ADDENDUM No. 2

INVITATION TO TENDERERS No.: 1220-020-2023-003

TITLE: GUILDFORD RECREATION CENTRE ROOF REPLACEMENT

ADDENDUM ISSUE DATE: JUNE 6, 2023

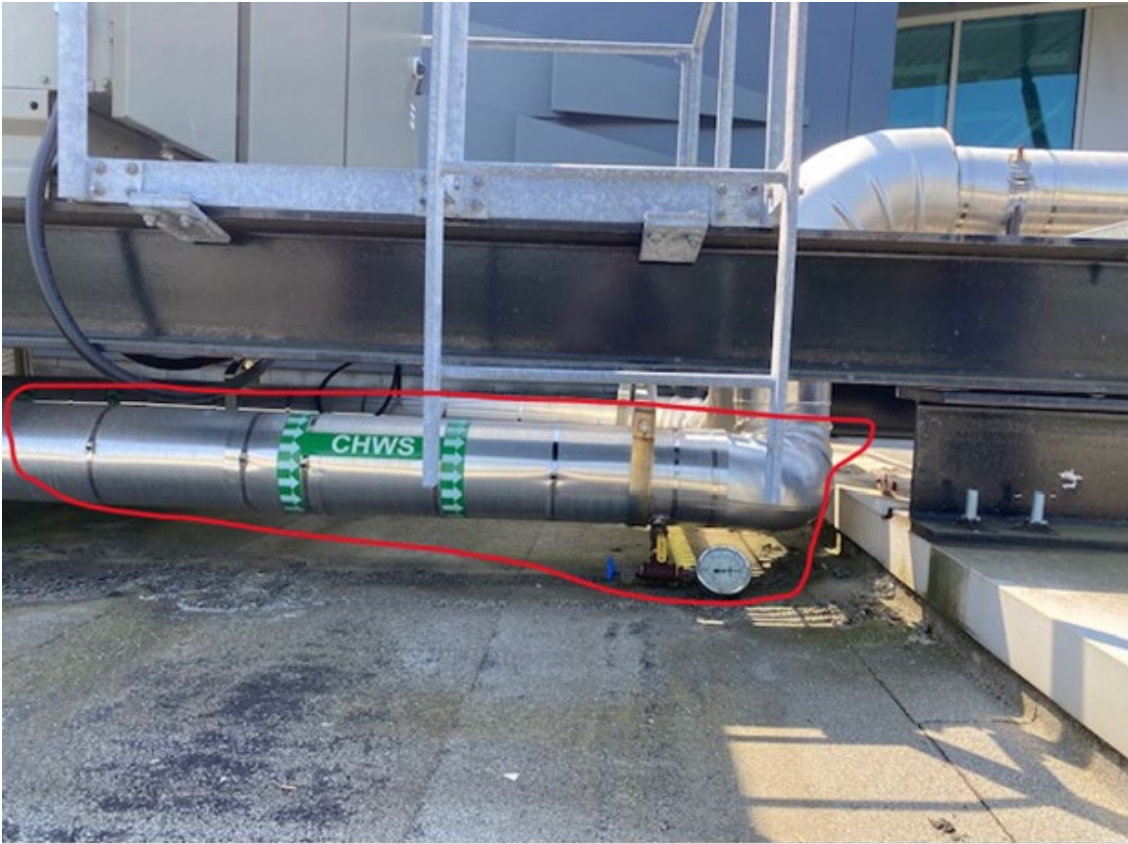
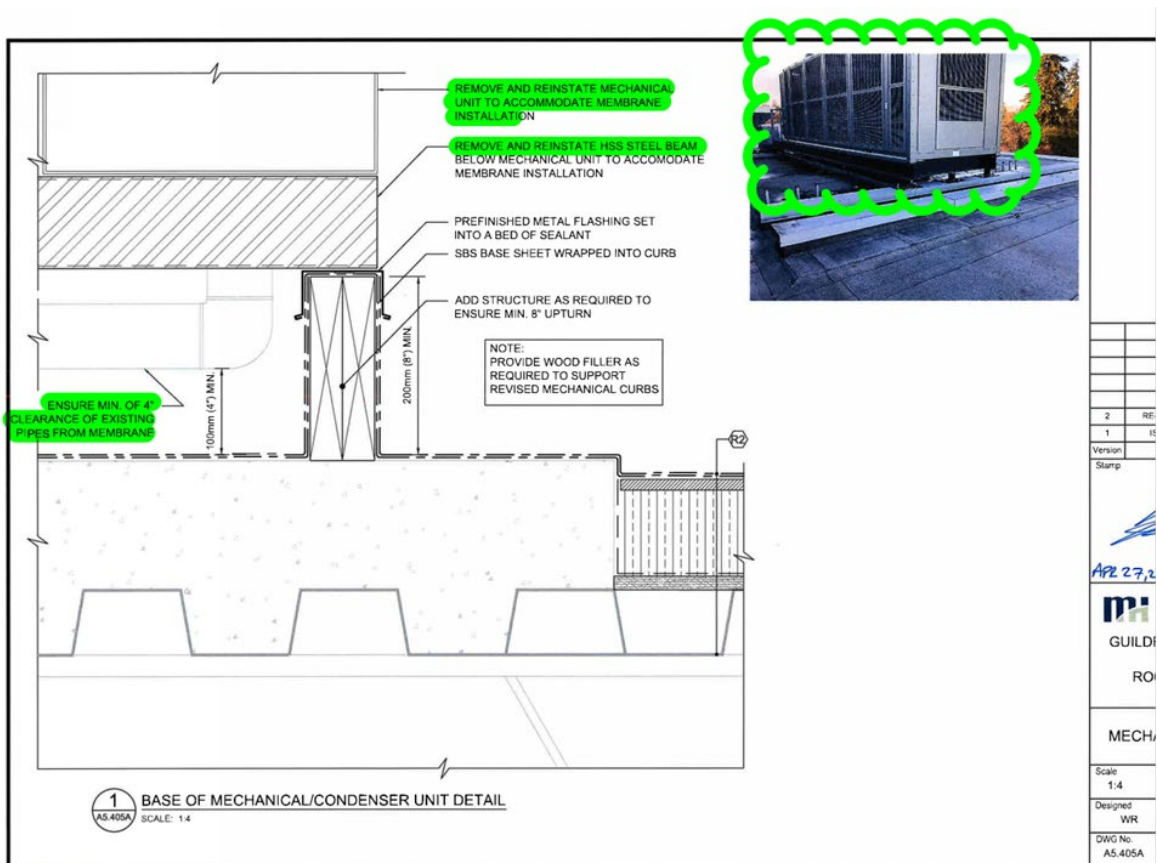
The City will perform the mechanical scope by removing the lower sections of pipes under the chiller unit for the duration of the roofing work and reinstalling the pipes when the roof section under the chiller and associated piping is complete. For clarity, the lower insulated pipes to be removed and reinstalled by the City have been circled in red in the following photos:

1. Delete the sections regarding the mechanical scope in Flat Roof Plan A: Item E of the Work on page 2 and page 8 of the ITT.
2. Tenderers are provided with two (2) options regarding the mechanical scope for the chiller and associated piping in Flat Roof Plan A:

Option 1: Roofing Contractor to perform and complete the roof replacement under the chiller and associated piping in the summer months in no more than 48 hours;
or

Option 2: Roofing Contractor to perform and complete the roof replacement under the chiller and associated piping from end of September to November.

Title
BUILDING SECTIONS REC CENTER

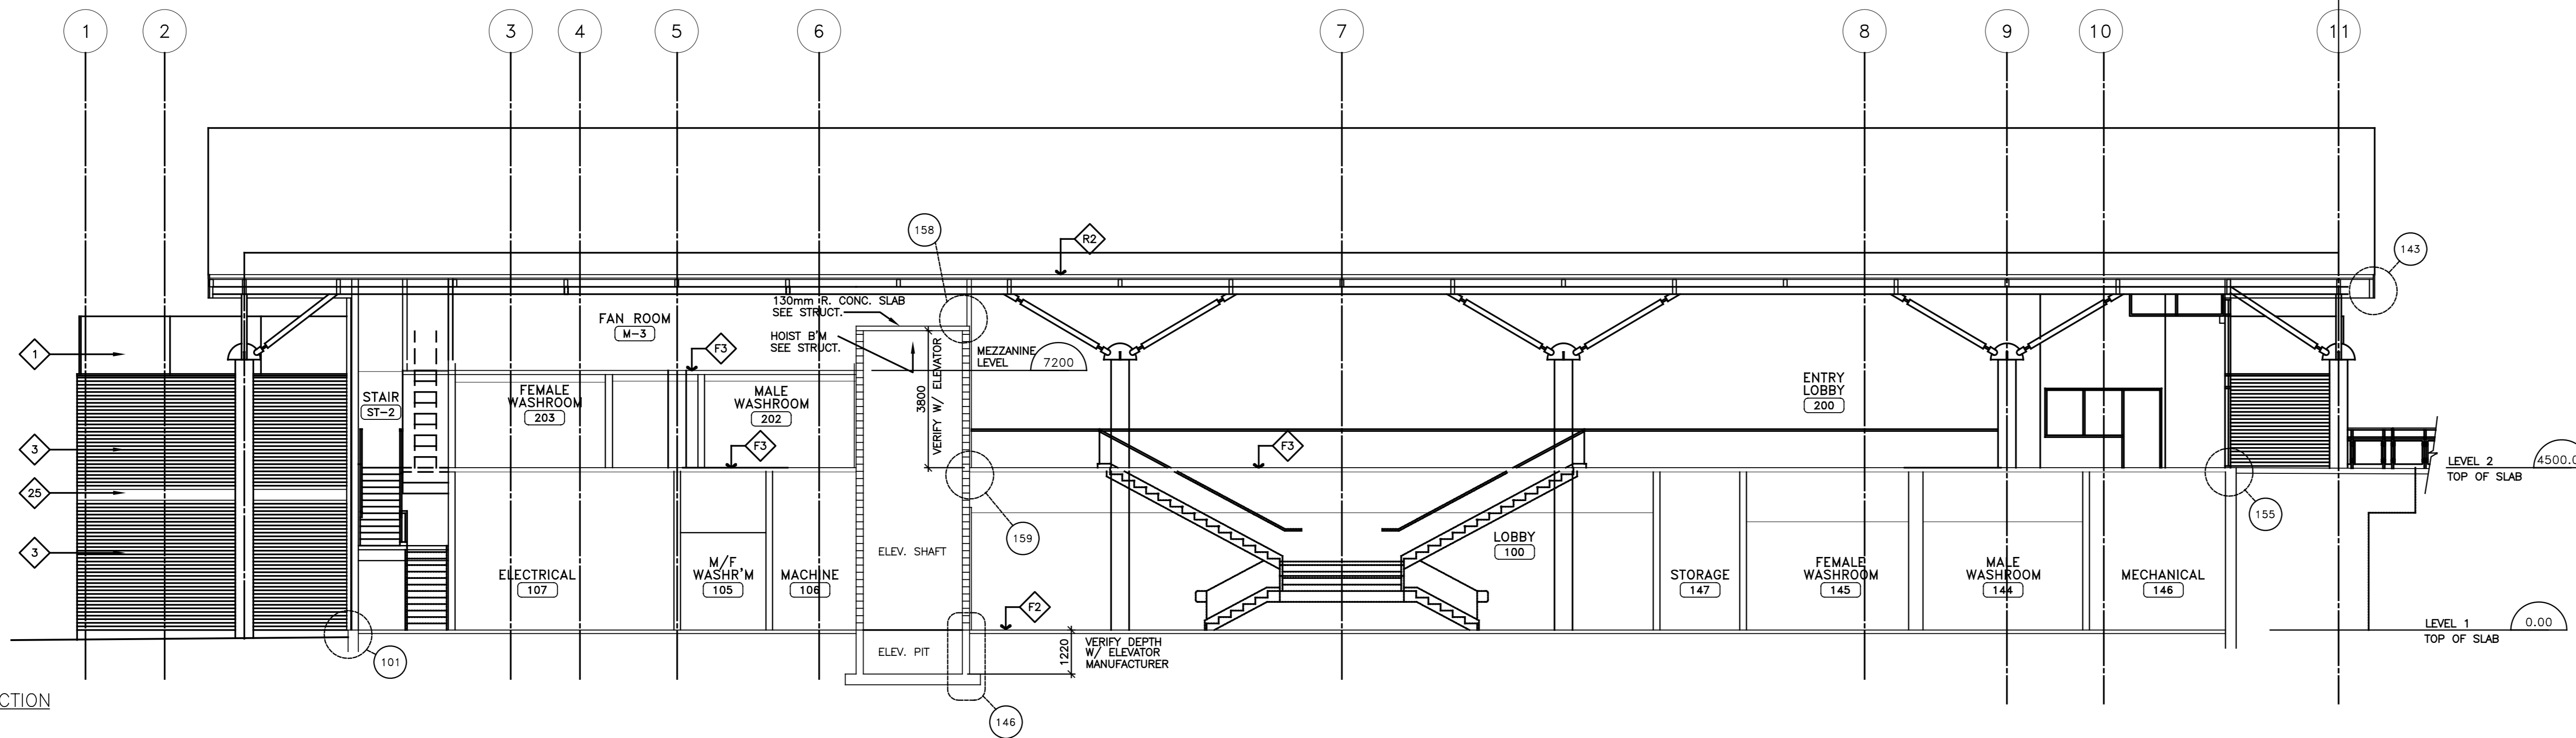
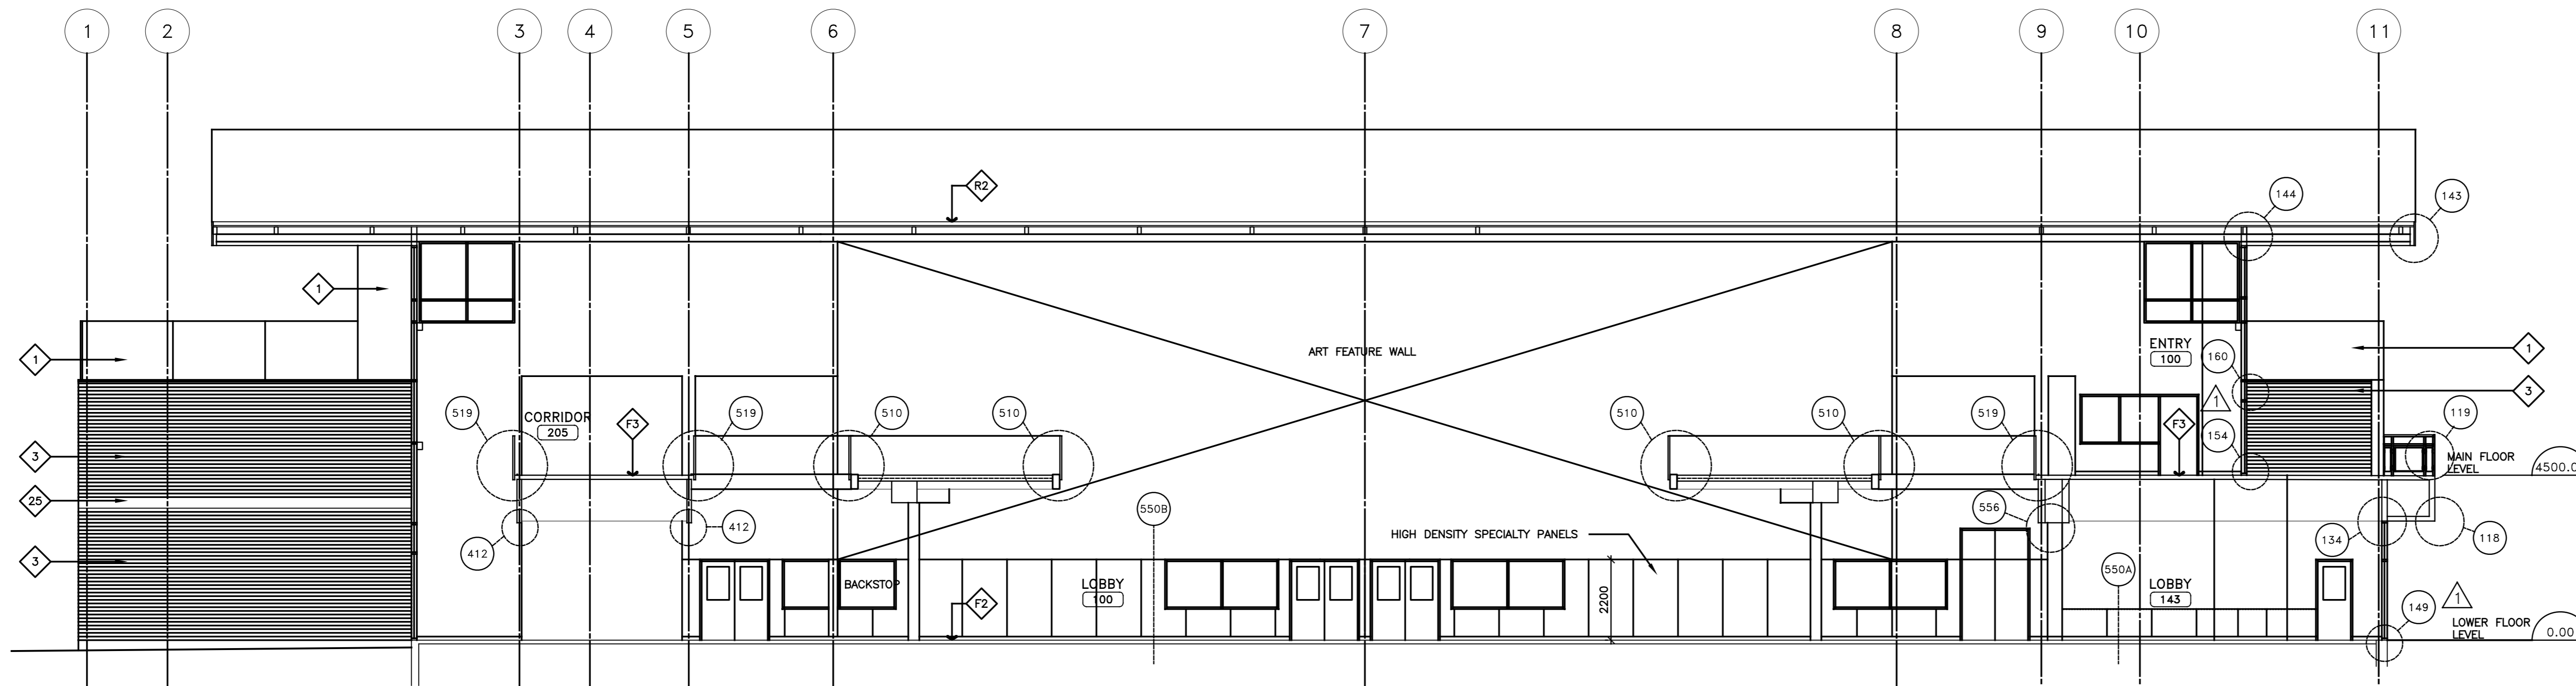
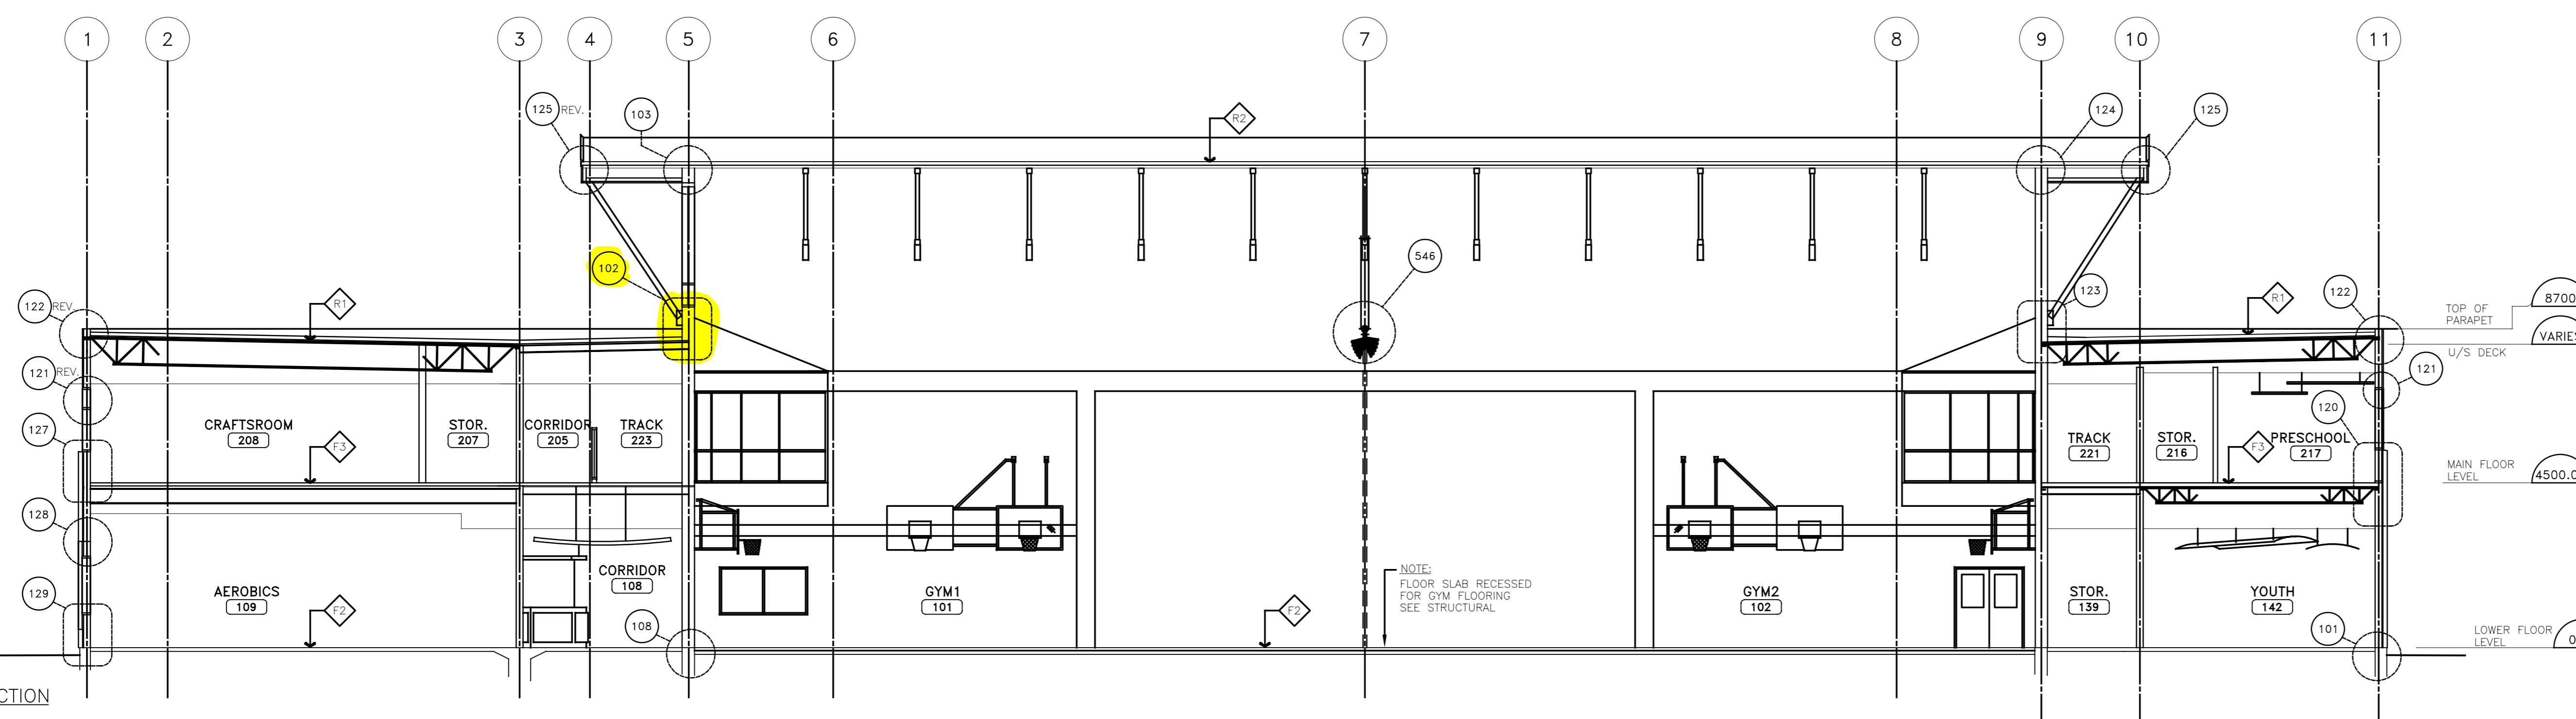
Q11. Some of the wall panels need to be removed for the waterproofing. Can we get the manufacturer details of these to help with how they come off?

A11. The Shop drawings were not available during the design process. Refer to Attachment No. 1 to Addendum No. 2 – Guildford Multi-Purpose Facility on page 7 for architectural as-built drawings showing wall panel details.
